record

Product Bulletin

Complete Line of New Arms Available October 3rd

Standard Arm

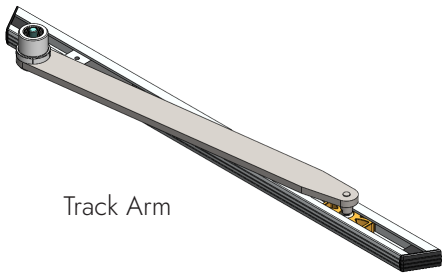
In August we proudly introduced our new & improved standard arm assembly for the Record 6100, 8100 and SimpleSwing product lines. We are pleased to launch the remaining arms to complete the offering. Starting October 3rd, all swing operators shipped from the Record facility will be supplied with the new arm assemblies.

- All steel components as opposed to aluminum.
- Powder coated grey color to better match common door hardware and provide scratch resistance.
- Reveals up to 12" standard.

- Extension available for reveals up to 16" (will not need to field cut to achieve 13"- 16").
- Door portion retrofits exactly with former offering. No need to reprep the door for replacement arm conversion (same bolt hole pattern).

- Testing shows adaptor is more rigid and durable than original (will no longer be a weak link to the units and should extend life expectancy).
- Adaptor now integrates a 360 deg tooth engagement instead of a two point. This provides a stronger assembly with minimal failures in abusive conditions.

- 20, 35, 50 and 80mm height adaptors included in the offering.
- Dark bronze and black arms will be in inventory at all times, and will match nicely while limiting the current issue with chipping paint.

- No cutting in the field when extension adaptor is included (in progress to add adaptor).
- No increased cost.
